2020 Corvette: Service Bulletin: #N202302840: Service Update - Door Paint Chipping

Subject: N202302840 — Door Paint Chipping
Models: 2020 Chevrolet Corvette

Release Date: April 2020

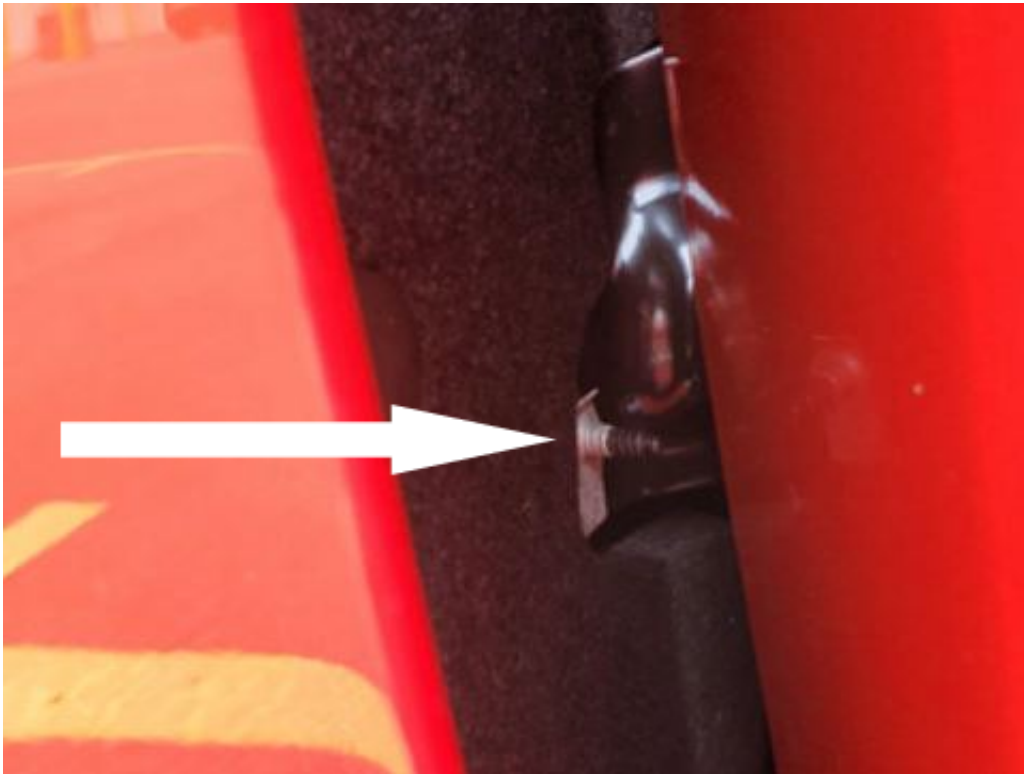
Certain 2020 model year Chevrolet Corvette vehicles may have a fender mounting bolt that is too long, and could come in contact with the door.

1. Carefully open the left front door inspecting for any contact with the fender fastener. This fastener is located just below the door check strap area.
2. Locate the threaded portion of the fender mounting bolt where it exits the nut.
3. Count the number of threads showing.

- If less than 1 full thread is showing, no further action is required.

- If more than 2 threads are showing, proceed to step # 4.
 - Partially remove the wheelhouse liner to access the rear fender mounting fasteners. Refer to *Front Wheelhouse Liner Replacement* in SI.
1. Locate and remove the center fender to body fastener as shown.
 2. Install the shorter service fastener. Tighten 9 Nm (80 lb in).
 3. Reinstall the wheelhouse liner. Refer to *Front Wheelhouse Liner Replacement* in SI.
 4. Repeat steps 1-7 on the right side of the vehicle.
